PRESERVING AUSTRALIA'S OLDEST GARDEN SUBURB

5 August 2015

Revision of the Hunters Hill Development Control Plan (DCP) Chapter 4

Diagram 1. Desired transition of building heights showing an orderly progression of building heights across different character areas

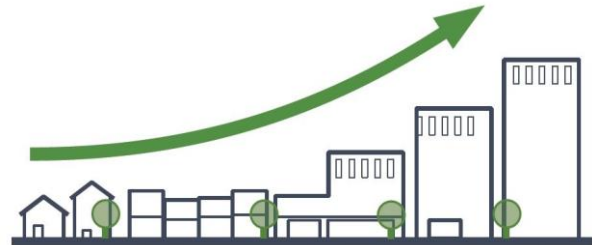
To ensure the spirit and intent of these objectives are more clearly understood by all stake holders (developers, community members, and relevant planning authorities), a stipulated set of measures should be included to codify the maximum height transition from one height zone to another, and additionally from one building to another.

Although it is not the responsibility of the author to articulate these controls, it is recommended that a maximum height increase to a neighboring height zone be considered for inclusion.
